AMENDMENT TO PROVISIONAL OPERATING LICENSE

Amendment No. 66
License No. DPR-13

ATTACHMENT TO LICENSE AMENDMENT NO. 66

PROVISIONAL OPERATING LICENSE NO. DPR-13

FIGURE 6.2.2.2 FACILITY ORGANIZATION

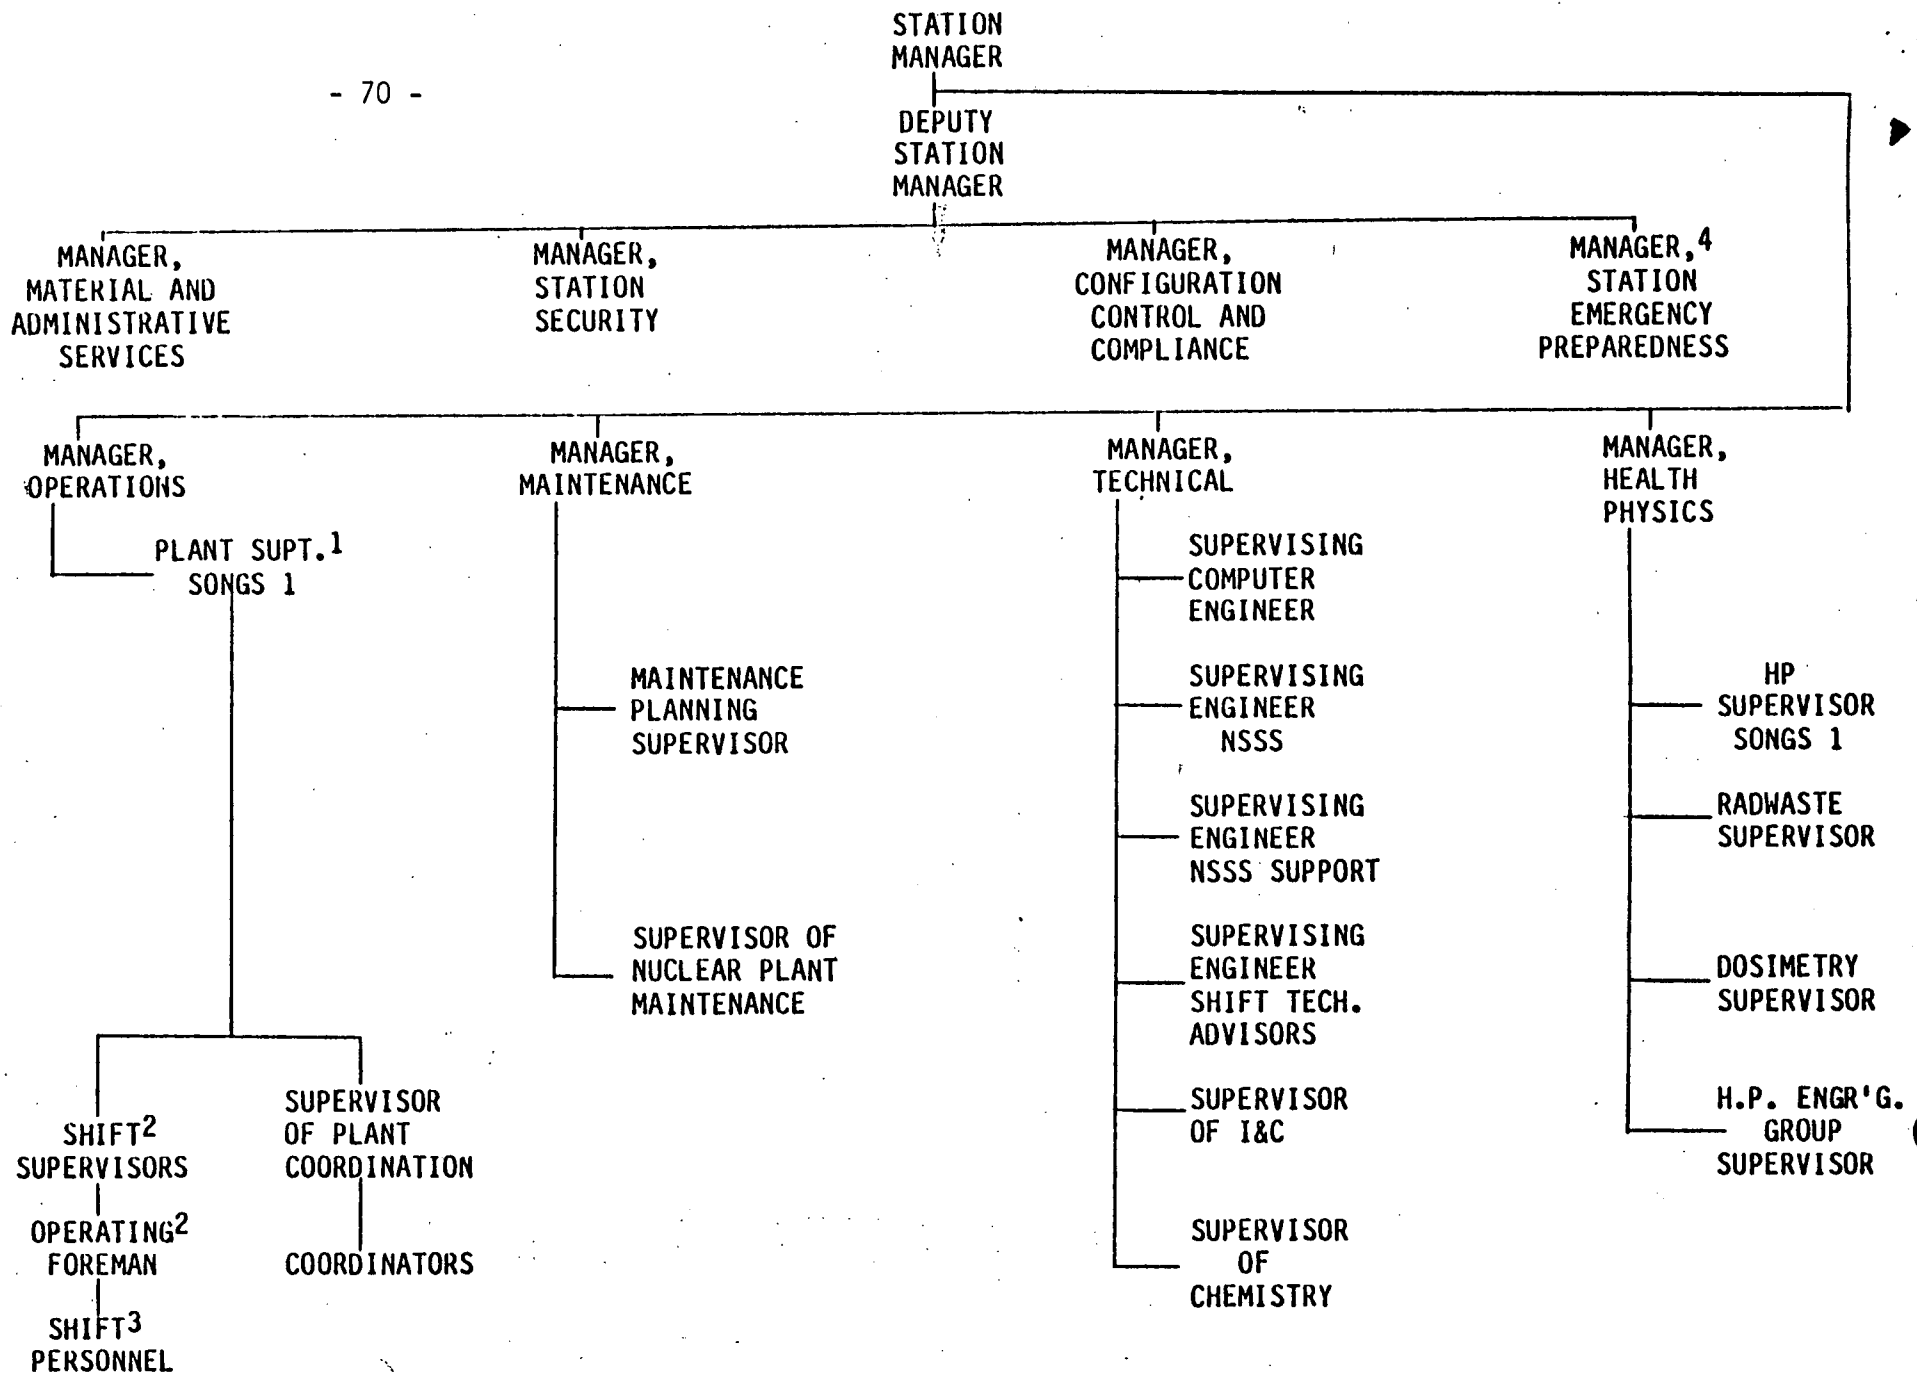
- 6.2.2 The Facility organization shall be as shown on Figure 6.2.2.2 and:
- a. Each on-duty shift shall be composed of at least the minimum shift crew composition shown in Table 6.2.2.2.
